**Virginia Board of Housing and Community Development**  
**CODES AND STANDARDS COMMITTEE**  
**2021 CODE CHANGE CYCLE – BOOK 4**  
**December 12, 2022**

### 2021 Uniform Statewide Building Code – Proposed Regulation Draft

##### Virginia Uniform Statewide Building Code

Figure R301.2(5)A ULTIMATE DESIGN WIND SPEEDS  
 8. Change Figure R301.2(5)B to read:

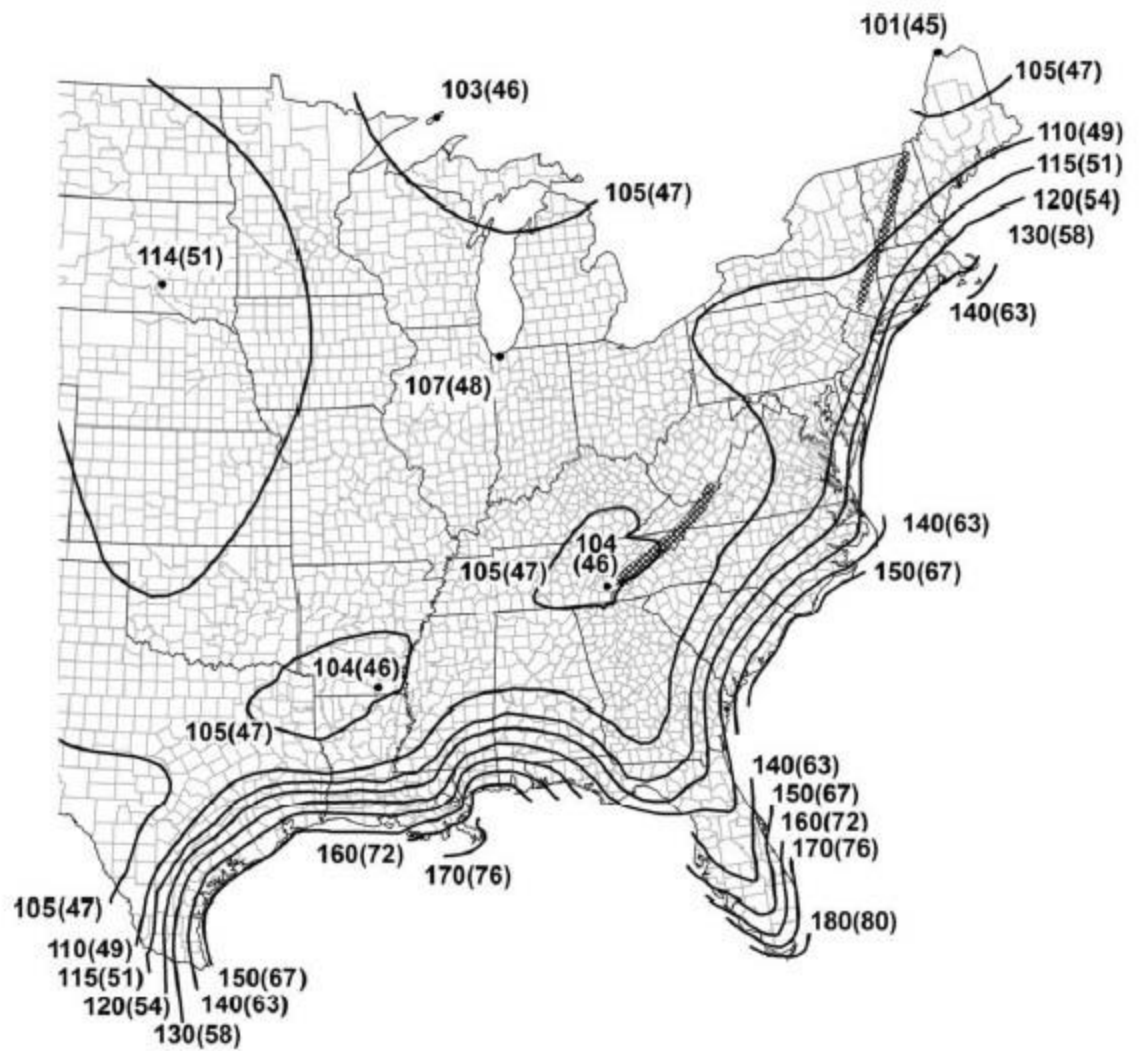
7. ~~Change Figure R301.2(5)A to read:~~

Figure R301.2(8) COMPONENT AND CLADDING PRESSURE ZONES

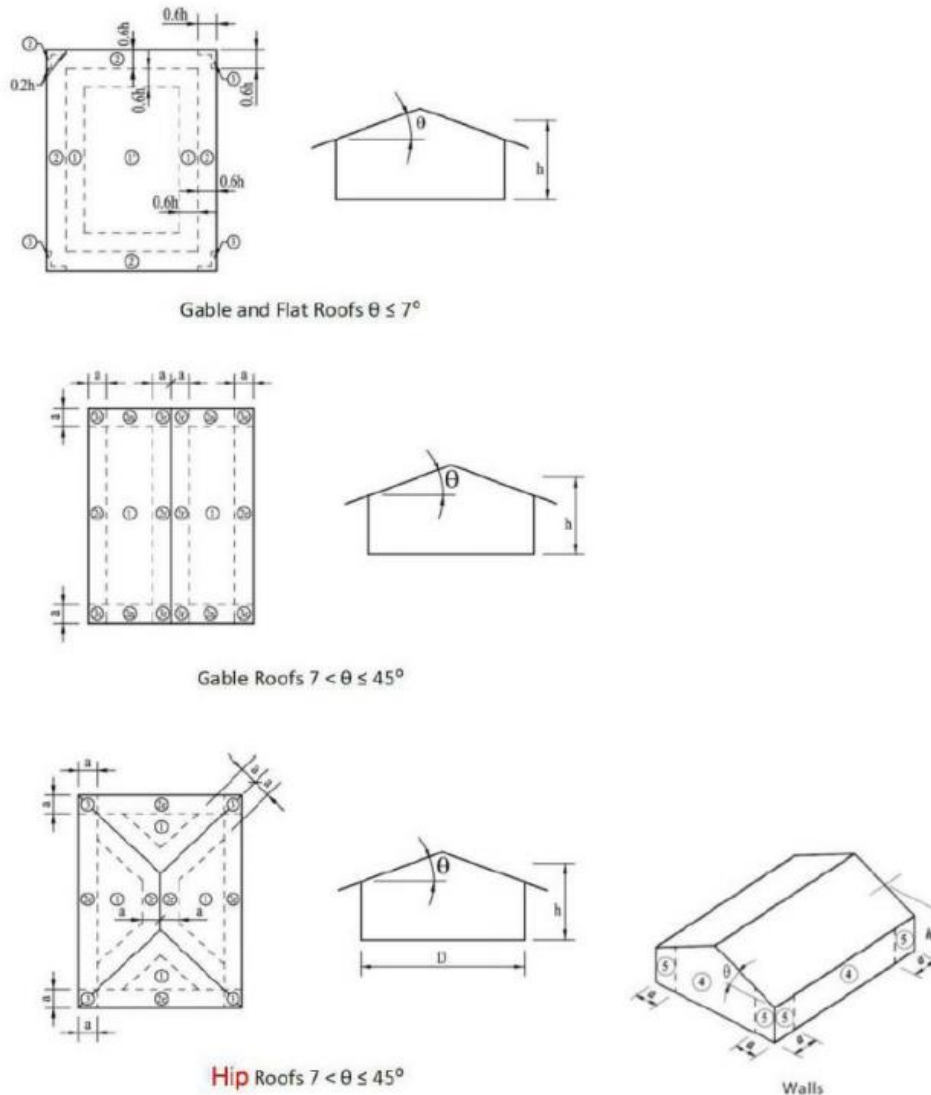
Figure R301.2(5)B REGIONS WHERE WIND DESIGN IS REQUIRED  
 9. Change Figure R301.2(8) to read:

**Figure AQ104.1.3**  
**Loft Ceiling Height**

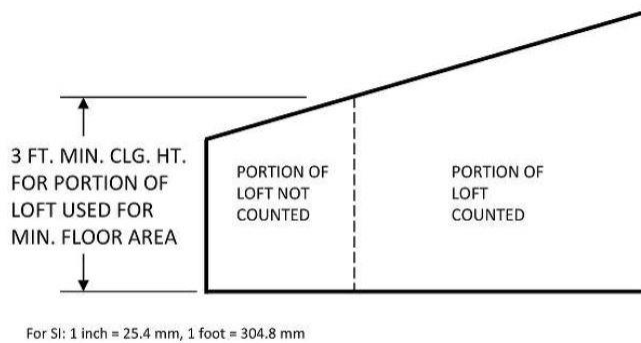
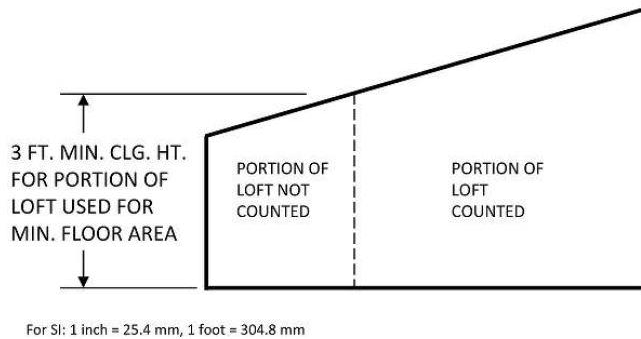
140. Add Figure AQ104.1.3 Loft Ceiling Height.

Exception: Under gable roofs with a minimum slope of 6 units vertical in 12 units horizontal (50% slope), portions of a loft with a sloped ceiling measuring less than 16 inches (406 mm) from the finished floor to the finished ceiling shall not be considered as contributing to the minimum required area for the loft. See Figure AQ104.1.3.

**FIGURE 1609.5 TORNADO-PRONE REGION**

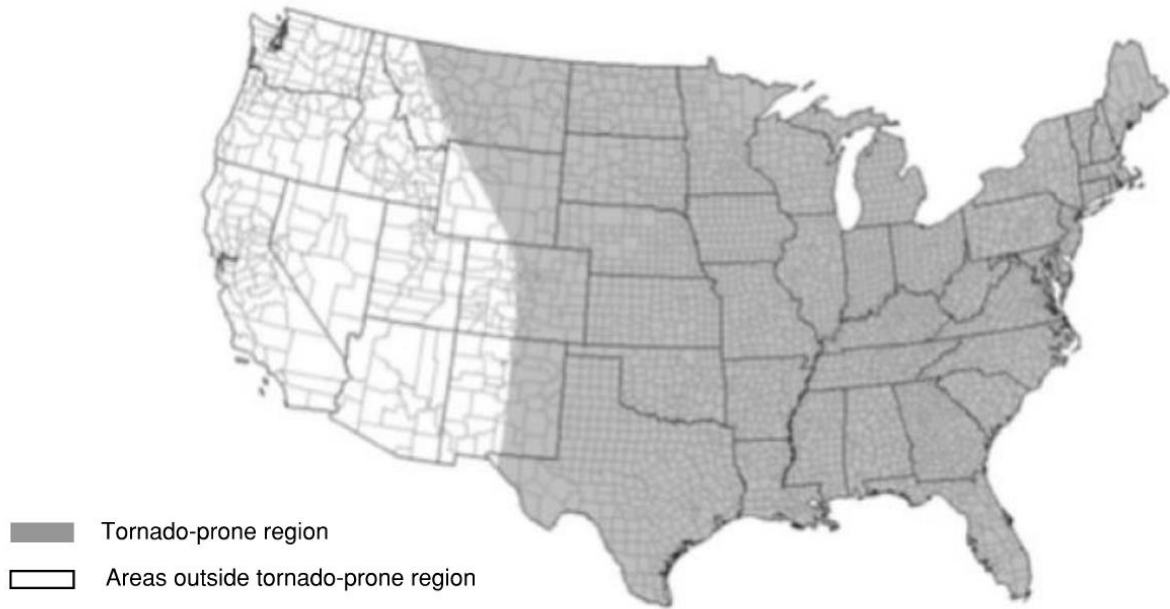
G. Add Figure 1609.5 TORNADO-PRONE REGION to the IBC.

1609.5 Tornado loads. The design and construction of Risk Category III and IV buildings and other structures located in the tornado-prone region as shown in Figure 1609.5 shall be in accordance with Chapter 32 of ASCE 7, except as modified by this code.
